August 8, 2022

Re: Environmental Noise Addendum Letter
Orleans Village (Phase 4), Ottawa
GW File No.: GW22-078 – Addendum Letter

FIGURE 2:
STATIONARY NOISE: RECEPTOR LOCATIONS

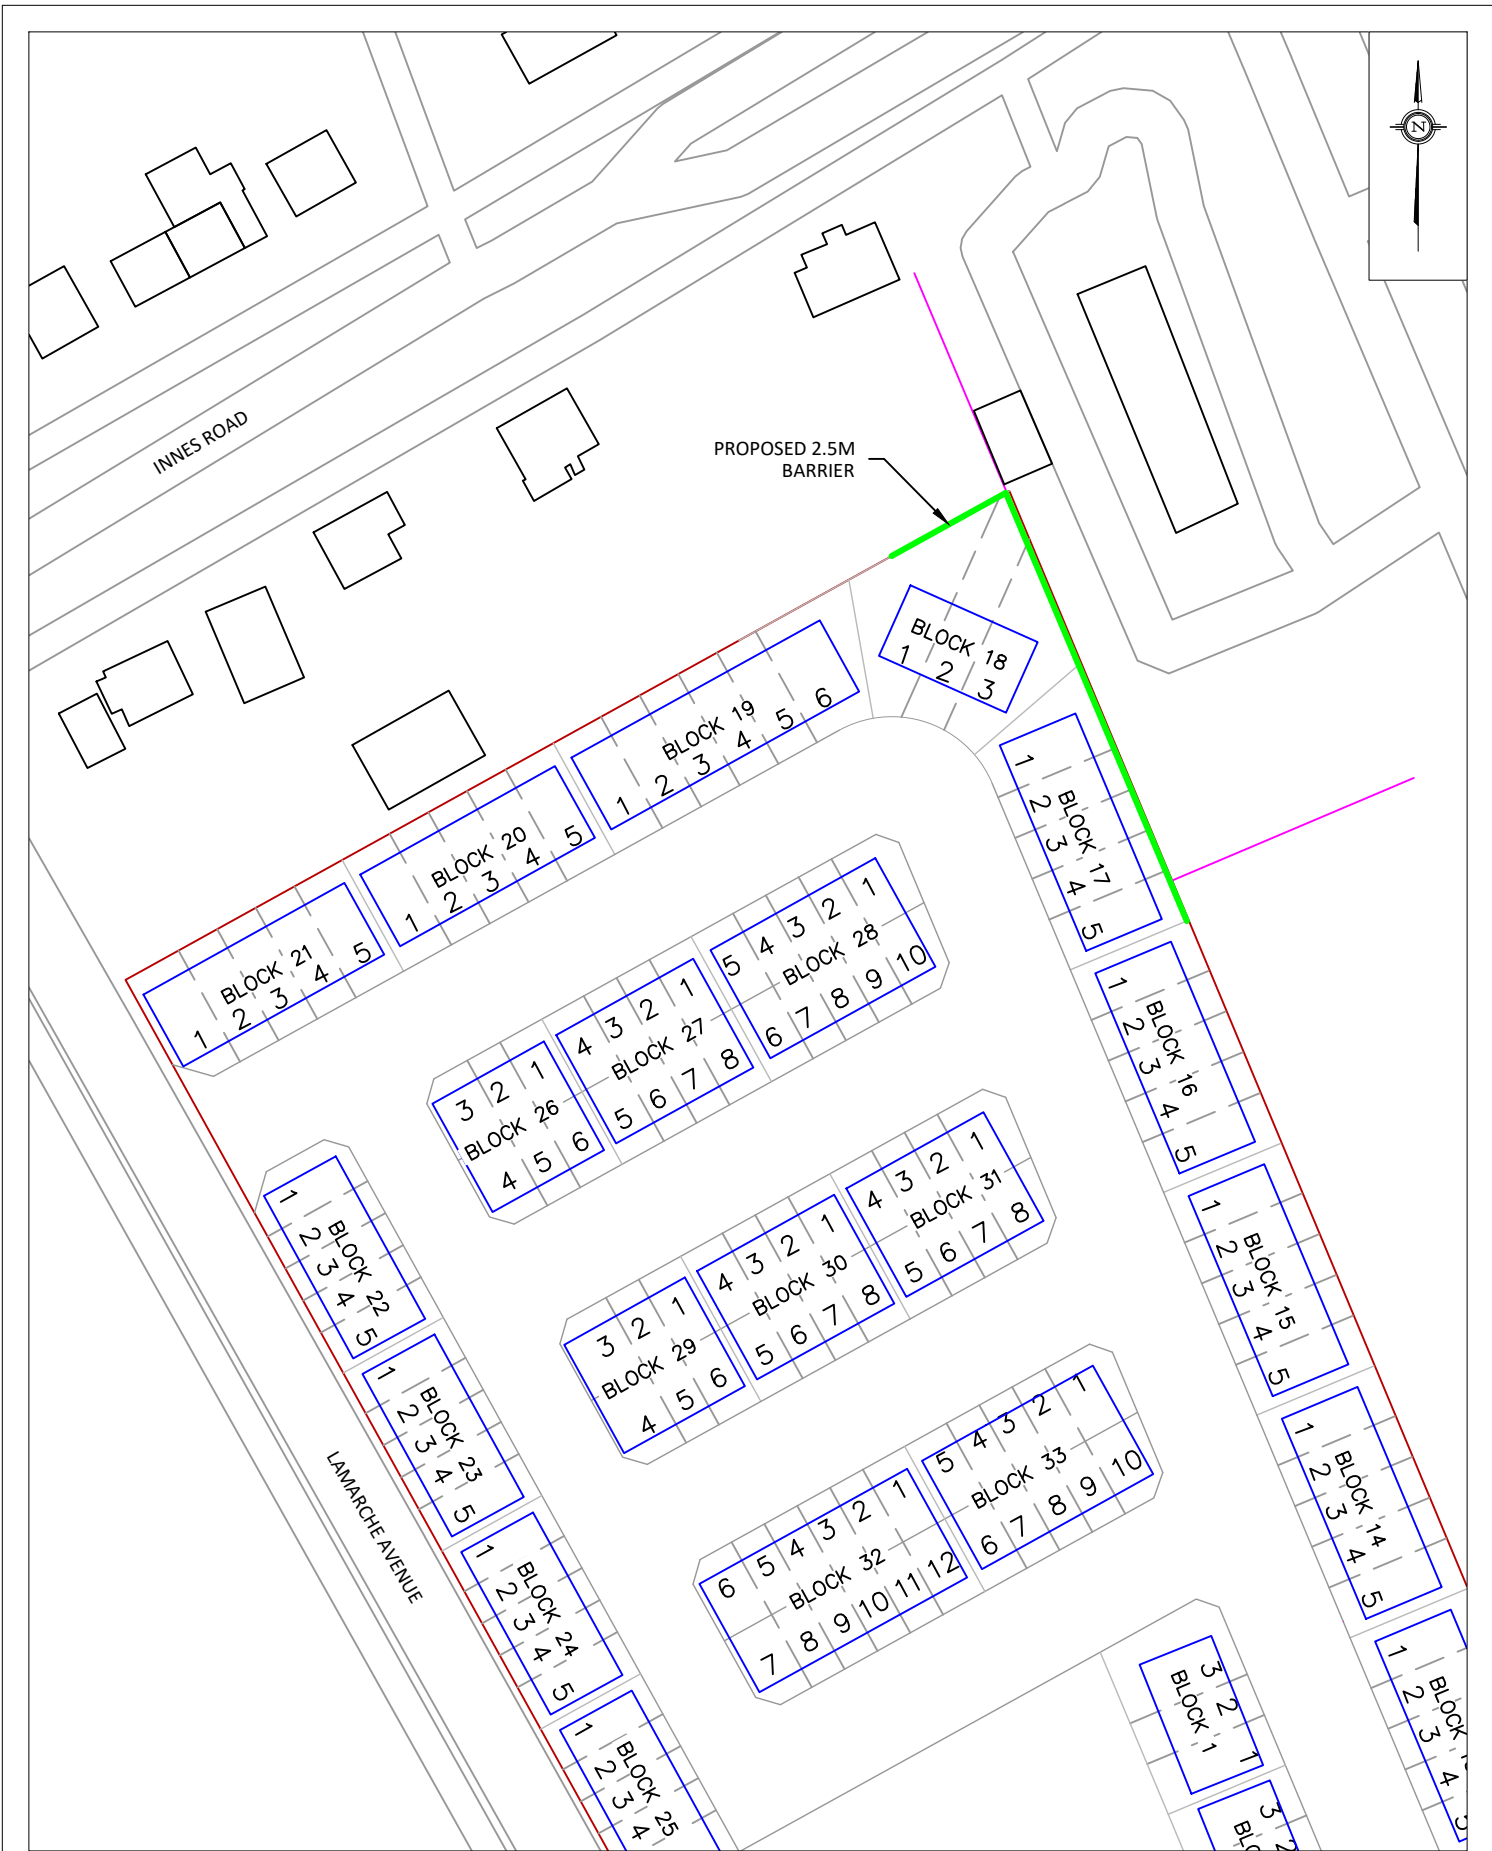
- 1. The noise study identified a 5m tall berm + noise barrier was required based upon the proposed site layout. Consideration should be made to:*
 - rearranging the subdivision lands to provide greater setbacks and result in a shorter required noise barrier, and/or;*
 - providing a different product type that would not include OLAs along the affected blocks. Note that it is the City's preference for mitigation measures that reduce the required height of the required noise barrier.*

- 2. Assess the land requirements on site to accommodate the grading of a 2.5m high berm (refer to berm setbacks within the City's Noise Control Guidelines), since the maximum barrier height that is acceptable is 2.5m. Ensure providing required barrier/berm height is feasible within the proposed block size. Alternatively, discuss the need for a retaining wall.*

As per the City's comments, Gradient Wind investigated the noise mitigating effects of implementing a 2.5 m tall noise wall/berm situated at the northeast corner of the property onto the development, primarily the rear yards. Noise receptors and the proposed barrier location are outlined in Figures 2 and 3, respectively. The proposed barrier length was also reduced such that it terminates at the boundary between Blocks 17 and 16.

The result of the current assessment indicates that noise levels can be reduced for a majority of the rear yards with the implementation of a 2.5m tall noise barrier/berm that terminates between Blocks 17 and 16. The rear yard of Block 18 is expected to experience a slight exceedance over the OPOR criterion with the 2.5 m barrier/berm. It should also be noted that the human ear is not able to perceive a difference in noise levels less than or equal to 3 dBA.
